From: Sara Roediger, AICP
Date: 2/3/2016
Re: **Goddard School**
Preliminary/Final Site Plan - Planning Review #2

From: Nancy McLaughlin
To: Ed Anzek
Date: 11/17/15
Re: File No.: 15-018
Project: Goddard School Review #1
Parcel No: 70-15-35-226-001
Applicant: Swapna Chada

From: Craig McEwen, Building Inspector/Plan Reviewer *CPM*
To: Sara Roediger, Planning Department
Date: February 2, 2016
Re: Goddard School – Review #2
Sidwell: 15-35-226-001
City File: 15-018

From: Jason Boughton AC *JRB*
To: Sara Roediger, Manager of Planning
Date: February 10, 2016
Re: Goddard School, City File #15-018, Section #35, Site Plan Review #3

CITY OF ROCHESTER HILLS
STANDARD DETAIL FOR:
Sight Distance Roadways

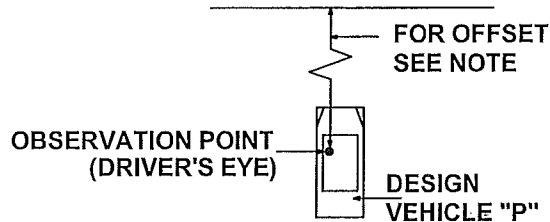
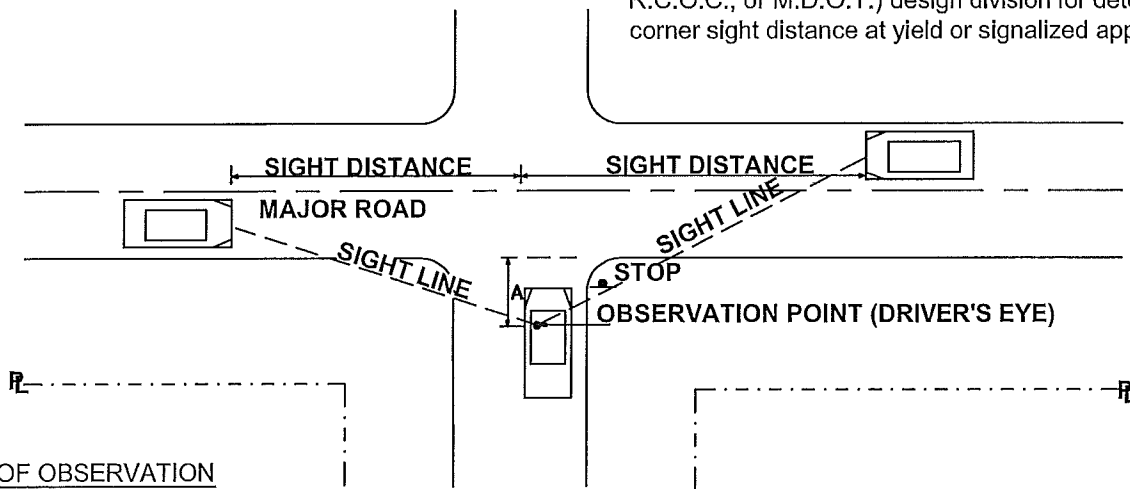
1. The sidewalk easement will need to be submitted and approved for the portion of existing sidewalk outside the ROW along Graham Drive prior to Land Improvement Permit issuance.
2. Indicate on the site plan that turning spaces will be provided at the intersection of the existing pathway/sidewalk with the internal sidewalks.
3. Show distinction between the existing surface type (concrete or asphalt) along the Auburn Road pathway. The path transitions from concrete to asphalt about 50 feet east of Graham Dr.
4. On Sheet LA-1.0, show the path and road sight distances east along Auburn Rd per the attached details.
